DOMINION VIRGINIA POWER
NORTH ANNA UNIT 3 COMBINED LICENSE APPLICATION
SRP 12.02: REVISED RESPONSE TO RAI LETTERS 146 AND 147

RAI No. 7703, Question 12.02-21

RAI No. 7704, Question 12.02-22

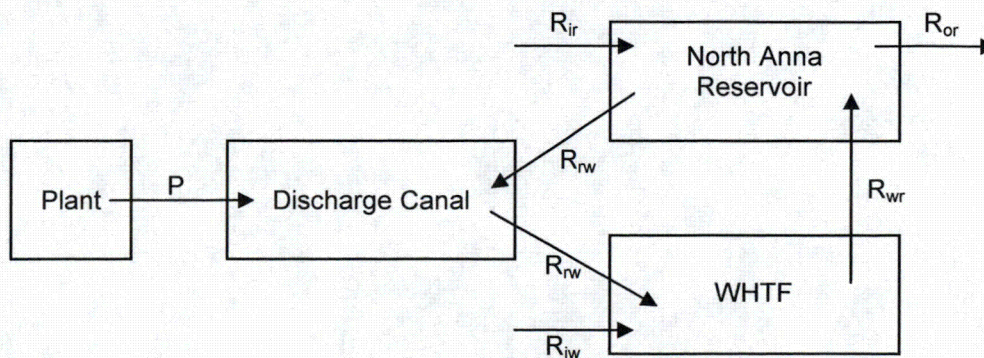
Please explain the source term calculations related to assessing the 10 CFR 20 requirement calculation(s) involved for all radionuclide values in the Unit 3 Annual Release column 2, MBq/yr to Unit 3 Concentration column 4, Bq/m³ and all radionuclide values in Unit 3 Annual Release column 3, Ci/yr to Unit 3 Concentration column 5, uCi/ml in a footnote or note at the end of the table.

I-131 release rate of 2.29E+02 MBq/yr is from DCD [Ref 1] Table 12.2-19b.

The concentration in the discharge canal is calculated using the following model from the UFSAR of Units 1 and 2 [Ref 2, Sec 11.2.5.1]:

The Units 1 and 2 UFSAR model also considers evaporation from the North Anna Reservoir and the Waste Heat Treatment Facility (WHTF), but these removal terms are conservatively neglected for Unit 3 to maximize the concentration in the discharge canal.
